ASA-04 Signal ,Train Control and VMS - Prebid Queries and Responses 30 December 2021						
SN	Part	Section	Clause	Original Bid condition	Bidder's query	CMRL Response
1	Part 1	SECTION - IV. A BIDDING FORMS	NA	NA	Please provide editable electronic data for all BIDDING FORMs listed in SECTION - IV.	The bidder may create the editable form duly copying from the tender document published. The Authenticity and correctness of such documents will be bidders responsibility
2	Part 1	SECTION - IV. A BIDDING FORMS	4.4 Brief Description of Stages		Breakdown of the stage on Part 3 - PCC Table 1 and Part - 1 Bidding form. Please explain the correct breakdown of each stage. Part - 1 : Stage1、 2、 3A、 3B、 4A、 4B、 5、 6、 7A、 7B Part - 3 : Stage1、 2、 3、 4A、 4B、 5、 6、 7.	Stage 3 consists of 3A and 3B and stage 7 consists of 7A and 7B with common commissioning dates.
3	Part 1	Section - III. EVALUATION AND QUALIFICATION CRITERIA (EQC)	EQC 2.4.1	Experience under contracts in the role of prime contractor (single entity or JV member), subcontractor or management contractor (i) for at least the last SEVEN (7) years starting 1st July 2014.	Is it correct to understand that "(i) for at least the last SEVEN (7) ye

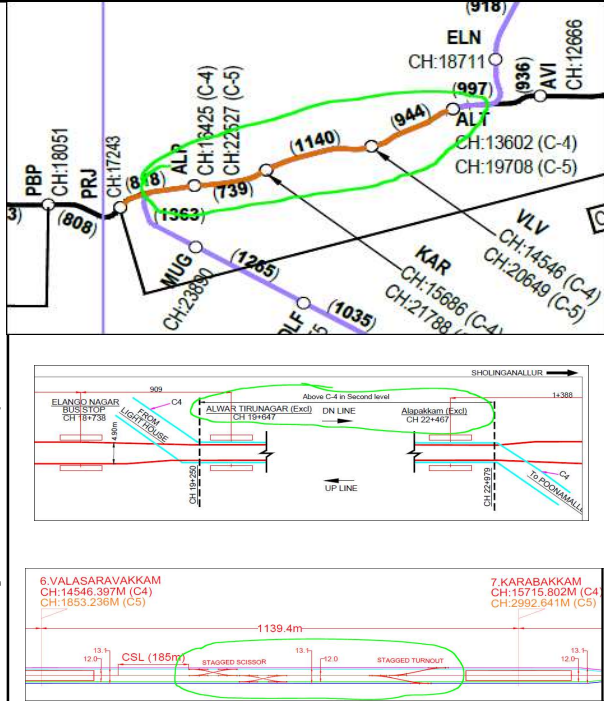
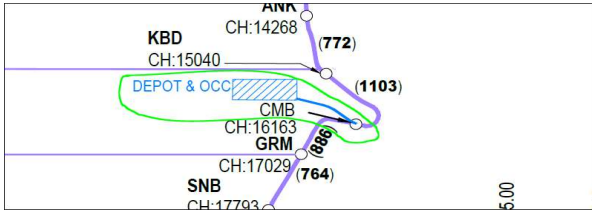
ASA-04 Signal ,Train Control and VMS - Prebid Queries and Responses 30 December 2021						
SN	Part	Section	Clause	Original Bid condition	Bidder's query	CMRL Response
668	Part 2	Safety Manual	4.3.2	<p>International Standards, Guidelines & ISO Certifications If the requirements stated in this document are in conflict or inconsistent with the requirements of applicable laws or the Employer's Requirements for the CMRL project, the more stringent requirements shall apply. The works shall be undertaken in accordance with the applicable international guidelines, standards and specifications on OHS&E and every Contractor shall actively</p> <p>Section VI-B Volume -1 OHS&E-Control</p> <p>1-9 February 2021</p> <hr/> <p>Chennai Metro Rail Project Phase 2, Corridor 3 TENDER No. CP22/ASA04</p> <p>Part-2 - Section VI-B Employer's Requirements</p> <p>pursue the achievement of:</p> <ul style="list-style-type: none"> ISO 45001:2018 Occupational health and safety (OH&S) management system ISO 14001:2015 Environmental management systems <p>The process of international certification to ISO 45001:2018 and ISO 14001:2015 standard shall commence immediately after the award of Contract through appointment of ISO-accrediting body for obtaining the certification. Should this not be undertaken by the Contractor within 3 months of the Contract award, the Employer /Engineer shall appoint at the Contractor's cost.</p> <p>Should the Contractor already possess such certification, the scope of the CMRL project must be included on the Contractor's certification within 1 year of Contract commencement and proof of such attainment demonstrated to Chennai Metro Rail Limited.</p> <p>If any of the above mentioned clauses are not adhered penalty shall be imposed as per details given under penalty clause 4.8.3 of this document.</p>	<p>Hitachi Rail STS India Pvt. Limited is ISO 14001:2015 (EMS) and ISO 45001:2018 (OH&S MS) certified organisation.</p> <p>Once order awarded, Chennai Metro Project scope will be added into the existing certification for ISO 14k&45K after successful project ISO Audit. Also note that ISO audit is generally happens yearly. So certification within 3 months of contract needs to be diluted.</p>	Once order awarded, Chennai Metro Project scope shall be added into the existing certification for ISO 14K&45K after successful project ISO Audit is acceptable.

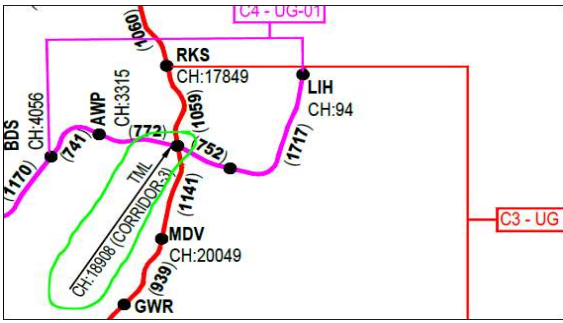
675	Part 2	Particular Specifications	14.5.5	The Contractor shall notify the Employer/Engineer promptly of any fixes or patches that are available to correct or patch faults.	We request the Employer to clarify the expected time to notify the Employer/Engineer. For example: within 5 business days etc.	promptly means 3 busineess days
676	Part 2	Tender Drawings	Corridor 4- GAD Track Plan		UG-01 1.Point chainages not available at Light House. 2.Two lines (UP & DN) are merging into a single lines at Kucheri Road, Alwarpet, and Bharathidasan road, but no Point cross over have shown. Please clarify. UG-02 1.Two lines (UP & DN) are merging into a single lines at Kodambakkam, but no Point cross over have shown. Please clarify. ECV01 1.Four stations common for Corridor C4 & C5. How these four stations will be operated? Is there separate lines for C4 and C5 for this common section? In GAD separate lines have not shown.	UG-01 . in C4, the tunnels follow same horizondal profile in many areas. IN these locations, the tunnels are one above the other. IG-02 . in C4, the tunnels follow same horizondal profile in many areas. IN these locations, the tunnels are one above the other. ECV 01 Four platforms exists per station. The upper platforms accomodates Corridor 5 and the lower platforms accomodates corridor 4. The track area (UP, DN lines) of C4 and C5 are completely segregated and are in two different levels.
